<b>Date of Meeting</b>	16 <sup>th</sup> October 2014
<b>Application Number</b>	14/06864/FUL
<b>Site Address</b>	Land to the west of Bake Farm Buildings Salisbury Road Coombe Bissett Salisbury SP5 4JT
<b>Proposal</b>	The erection of solar photovoltaic panels and associated works and infrastructure, including switchgear, inverter stations, access tracks, security fencing, security cameras, grid connection, together with temporary construction access, compound and unloading area
<b>Applicant</b>	Coombe Bissett PV Park Ltd
<b>Town/Parish Council</b>	BRITFORD
<b>Ward</b>	DOWNTON AND EBBLE VALLEY
<b>Grid Ref</b>	411789 127820
<b>Type of application</b>	Full Planning
<b>Case Officer</b>	Andrew Bidwell

#### 1. Purpose of Report

To recommend that the application be approved subject to conditions.

VIEWPOINT No. 4 PROPOSED with mitigation shown after 5-7 years growth

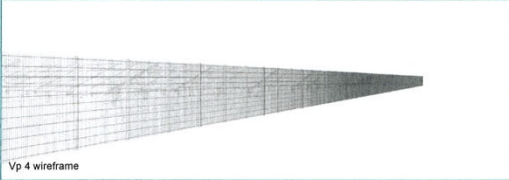
The photo-montages are helpful in some respects, nevertheless the confusion between the viewpoint numbers of the viewpoints plan, the viewpoint photographs, and the viewpoint photo-montages is confusing. For example the photo-montage indicated as viewpoint 17 appears to be 19 in other respects and similarly photo-montage 16 is 18 in other respects. Nevertheless, the photomontages of these viewpoints and others show the very considerable horizontal effect of the proposed development spread across a substantial part of the view. Furthermore, such a change brought about by the development would not change seasonally in the way that seasonal use of fields changes. The photo-montages also demonstrate that whilst the proposed mitigation planting might have benefits for close views those from a distance are not significantly ameliorated.

*“The location of field four, the field that adjoins the AONB, and the upper parts of field three are particularly obvious in views from a number of locations to the south and south west in the AONB. The proposed development would significantly change the character of the area and harm views from the AONB of the ridge, both within and outside of the AONB boundary. As those views are of a development facing southward it means that the development would be fully illuminated for most of the daytime and hence obvious in the scene.*

14. A revised LVIA chapter figure package is attached with corrections made to the viewpoint numbers highlighted by Mr Burden.
